**ADDISON AIRPORT
BUILDING REPORT**

Facility Information: Facility Name: 4553 Glenn Curtiss Drive
Facility Contact: Lisa Pyles Contact Phone: 972-450-2878

Accessology Inspector Information:
Inspector: Karen Jackson Date: May 3, 2017
Email: Kjackson@accessology.com

Violation 3 - There are no "van Accessible" parking spaces provided.

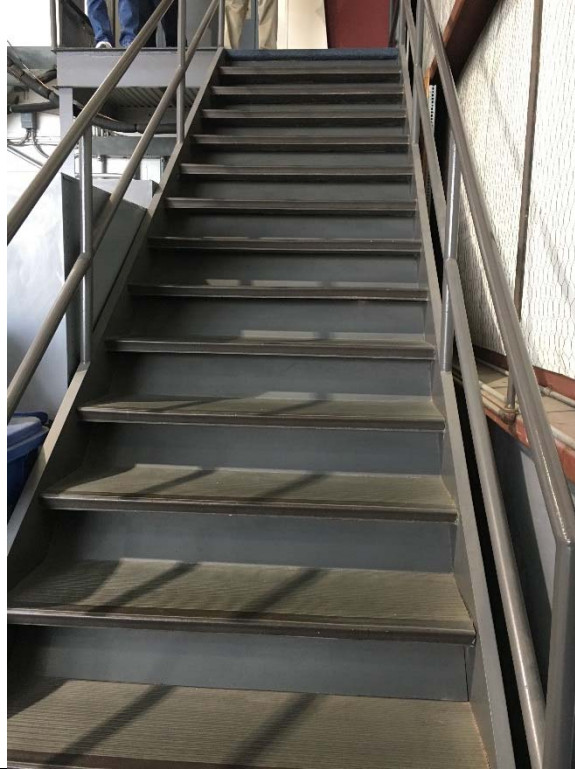
Violation #3: There are no "van Accessible" parking spaces provided.

Possible Solutions: Install van accessible signage.

Violation 5 - There is no accessible route to the 2nd floor of the building.

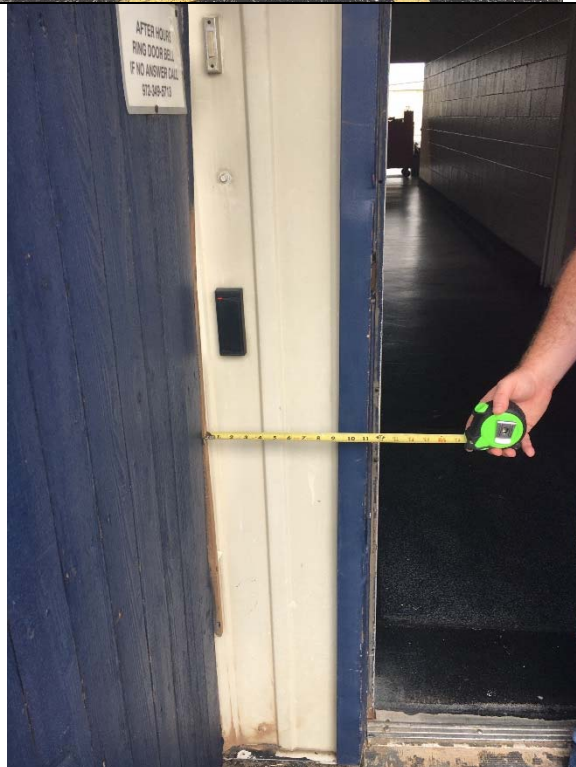
Violation #5: There is no accessible route to the 2nd floor of the building.

Possible Solutions: Add a fully compliant elevator when needed to accommodate an employee if an accommodation can not be made in a more accessible location. Until the elevator is needed, it's a low priority.

Violation 7 - There is only an 11" maneuvering clearance on the pull side at the entrance door.

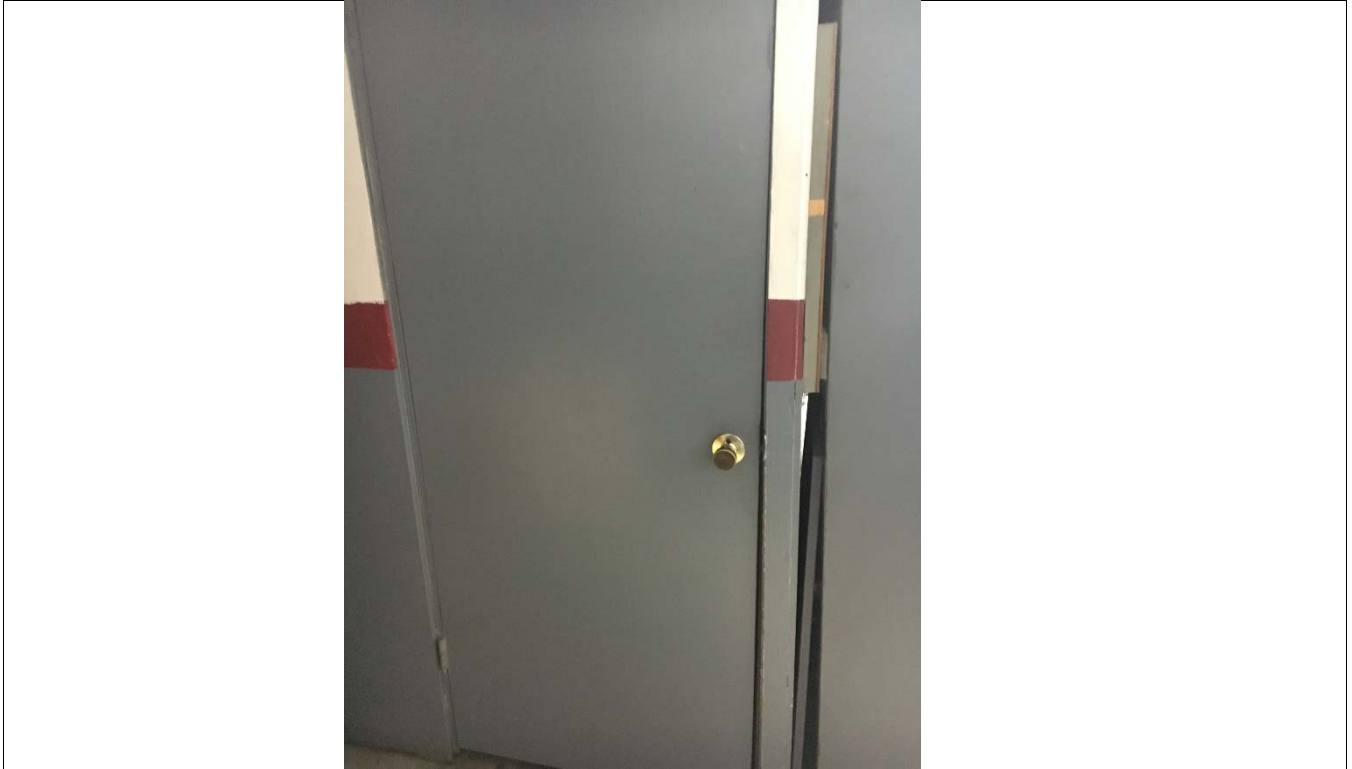
Violation #7: There is only an 11" maneuvering clearance on the pull side at the entrance door.

Modify entrance to provide the 18" minimum required maneuvering clearance.

Violation 8 - There are approximately 10 doors throughout the facility that have door hardware that requires twisting and grasping to operate.

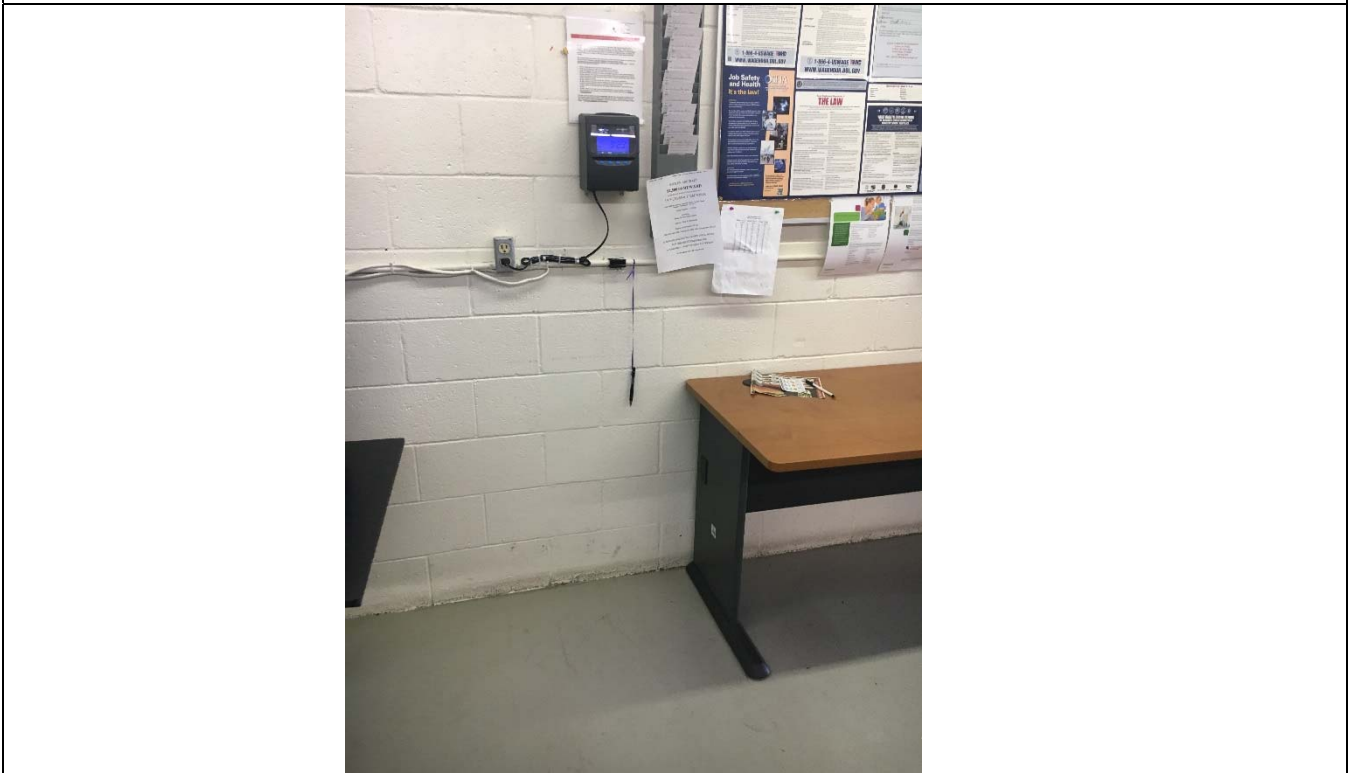
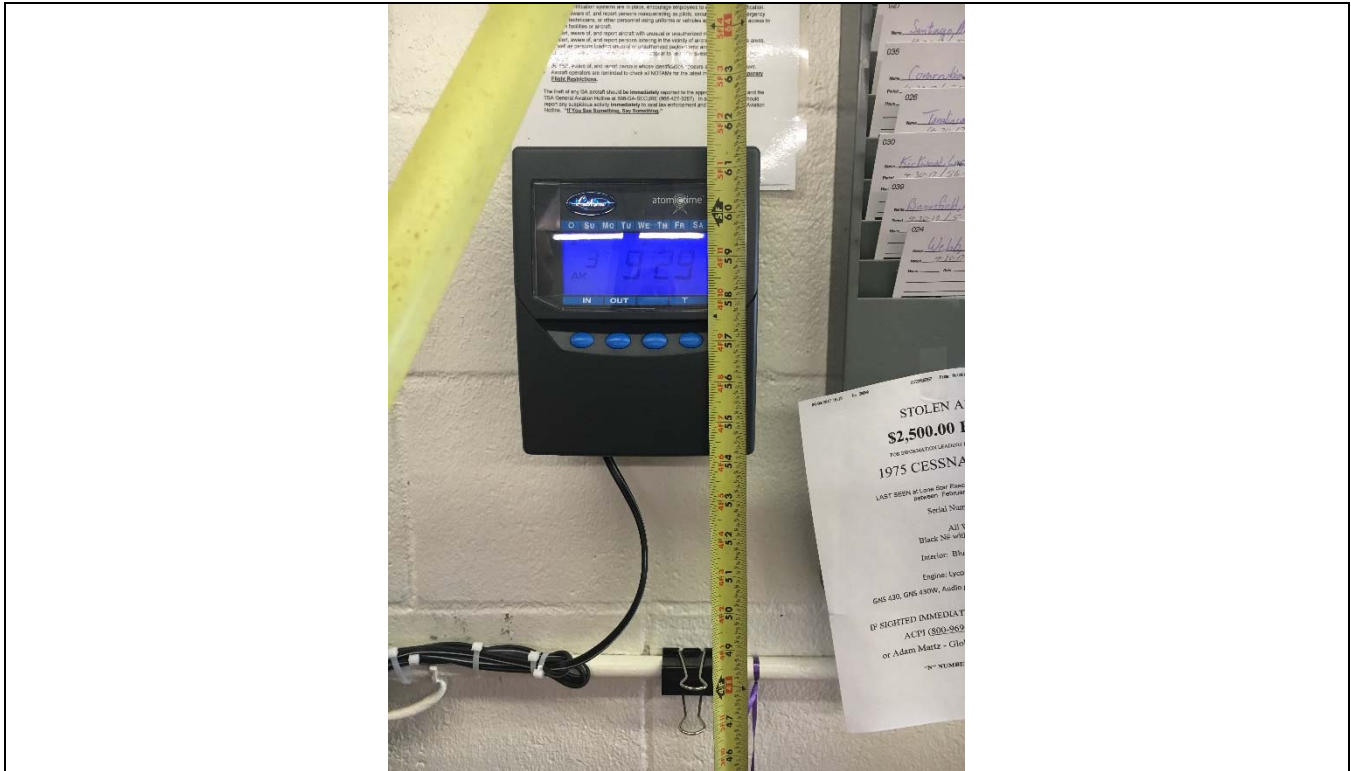
There are approximately 10 doors throughout the facility that have door hardware that requires twisting and grasping to operate.

Replace door hardware with lever type hardware.

Violation 10 - The time clock located in the break room is mounted with the highest operable part at 57" above finished floor where 48" maximum is required.

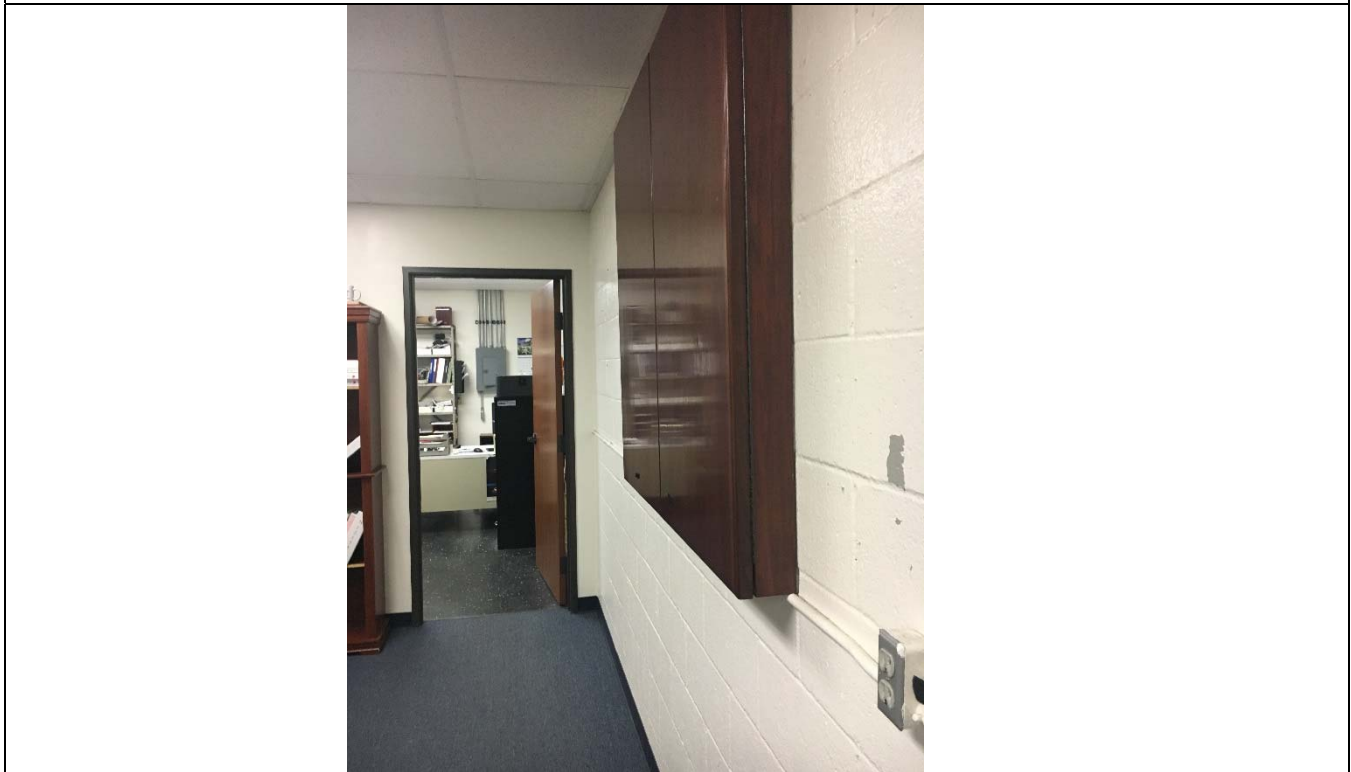
The time clock located in the break room is mounted with the highest operable part at 57" above finished floor where 48" maximum is required.

Lower the time clock so the highest operable part is no more than 48" above finished floor.

Violation 11 - The white board cabinet provided in the conference room protrudes into the path of travel 4-5/8".

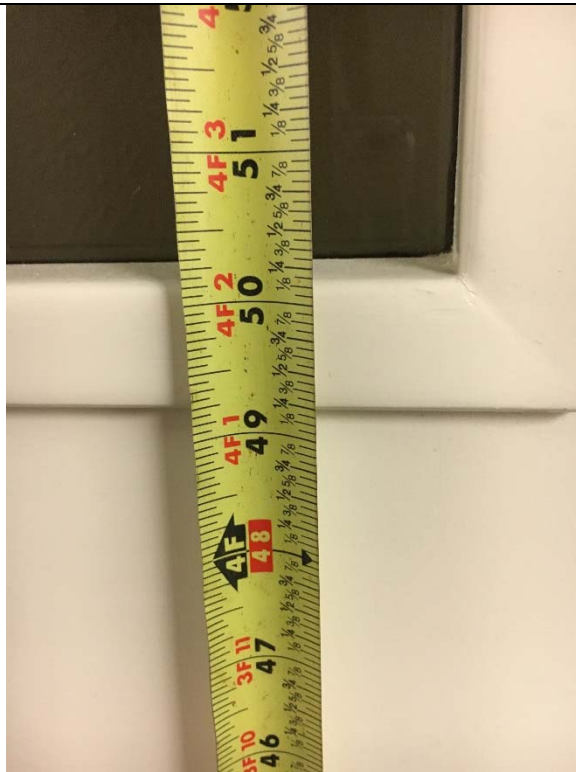
The white board cabinet provided in the conference room protrudes into the path of travel 4-5/8".

Remove whiteboard cabinet or relocate so that its leading edge is 27" maximum above the floor.
